2.0 Response to Key Issues

Response to Department of Planning Comments

Height envelope overlay: view from south  
Original SSDA submission overlaid with permissible height envelope

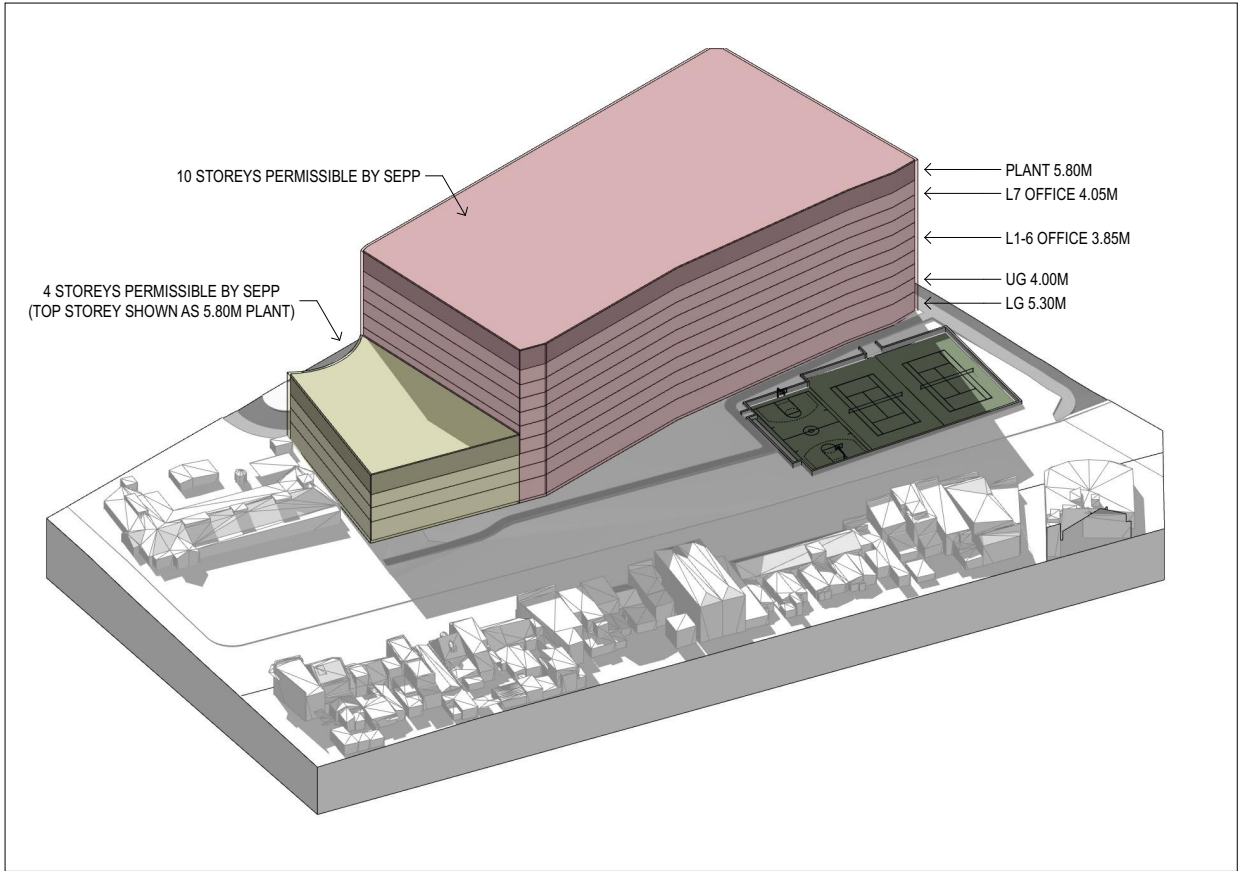
<p><b>Key Issue 1</b> <b>GFA and building height exceedances</b></p>
<p>Further justification should be provided to support the variations to the gross floor area (GFA) and height controls in State Environmental Planning Policy (Major Development) 2005 (MD SEPP) and the distribution of GFA across the site. In particular, a detailed analysis of the impacts arising from the combined non-compliances are required, including:</p> <ul style="list-style-type: none"><li>— a comparative analysis of the development as proposed and one that complies with the building height and GFA controls in 3D, plan and elevation format showing likely overshadowing impacts on neighbouring properties, particularly to the southern side of Henderson Road and the childcare centre to the west; and</li><li>— a comparative visual analysis (including photomontages) as above from vantage points assessed in the Visual Impact Study.</li></ul>

<p>The variation (redistribution) of GFA was noted on page 12 of the SSDA Design Report. The allowable GFA is 102,450 sqm. The proposed GFA is 107,430 sqm. This represents an overall increase of 4.86%. This GFA increase and the redistribution between the sites allows for the development of 2 state of the art, technology focused commercial buildings with ground floor amenity. These buildings have been adequately sized to accommodate CBA and also to cater for the necessary amenity which ATP requires to cater for the circa 15,000 people which will use ATP everyday in the near future.</p> <p>The redistribution allows CBA's brief to be met on the ATP precinct, thus ensuring the proposals for the redevelopment of ATP were successful against considerable competition from other sites. Additionally, the reduced scale of B3 allows the community building to have a scale appropriate for its usage and reduces overshadowing to the Vice Chancellors Oval.</p> <p>The extent and height of the B1 plantrooms have been reduced relative to the original SSDA submission. Through redesign 330sqm of roof top plant has been removed from the roof of B1. Through relocation of taller elements of plant to other areas the plant associated with the south west core has been reduced in height from 5.8m to 4.0m.</p> <p>The overshadowing and visual impacts of this modified SSDA proposal have been tested against the overshadowing and visual impacts of a GFA and height compliant scheme for B1. Additionally, a solar access study has been undertaken to examine the hours of direct sunlight achieved on the Henderson Road residences at mid winter. This study is included in the following pages of this report and demonstrates that the impact of the modified proposal are no greater than those of a GFA and height compliant scheme.</p> <p>The play space for the adjacent childcare centre is to the north of the existing centre. By virtue of the extent of existing shadows created by the Media City building, neither the modified proposed scheme, the notional height SEPP envelope as illustrated to the right, or the GFA and height compliant scheme create any additional overshadowing on this play space in mid-winter. The play space does enjoy nearly full solar access between 12pm and 2pm.</p> <p>The shadow analysis also reveals that the notational SEPP envelope has more impact on the childcare centre site as a whole than the proposed modified scheme, with shadows cast by the lower 4 story block on the boundary shadowing the southern side (car park) of the adjacent childcare.</p> <p>Photomontage visual impact studies have be undertaken and are included in the following pages of this report. These illustrate that the visual impact of the modified SSDA proposal is similar, and no greater overall than that of a GFA and height compliant scheme.</p>

Diagram showing build up of permissible height envelope as used for comparison purposes in original SSDA submission.
